City of Portland, Maine - Building or Use Permit Application

Subject: Application ID: 2008-0072

RE: **31 Forest Street, Parkview Terrace
2-unit Residential Condominium**

CBL: **053 A011001**
Application ID: **# 2008-0072**

CODE: IRC 2003
 TOWN: PORTLAND
 DATE: 08-26-08
 SCALE: AS NOTED
 DRAWN: JJO
 TITLE:
 REVISED TYP.
 SIDE ELEVATION
 FILE:
 SHEET:

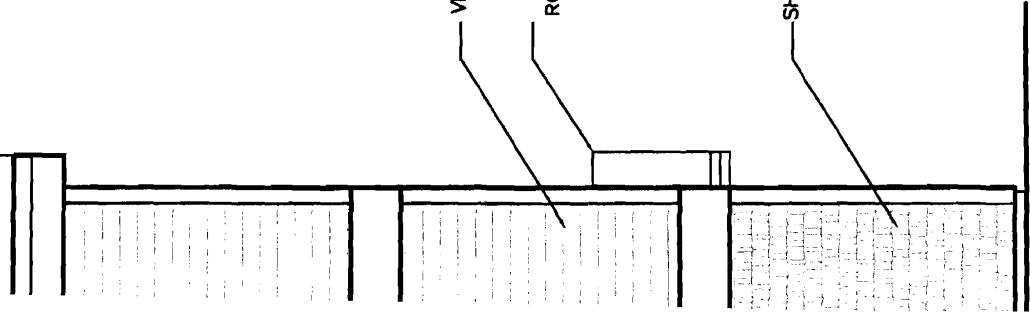
1. **Comment:** The introduction of a pitched roof may result in different calculations for setbacks as these are related to height.

height
→ **Response:** I have provided a new sheet entitled “Height/Side Setback Calculations” which depicts the critical elevation markers and a narrative which shows that the setbacks and building height work in accordance with the stipulations of the R6 Infill Ordinance.
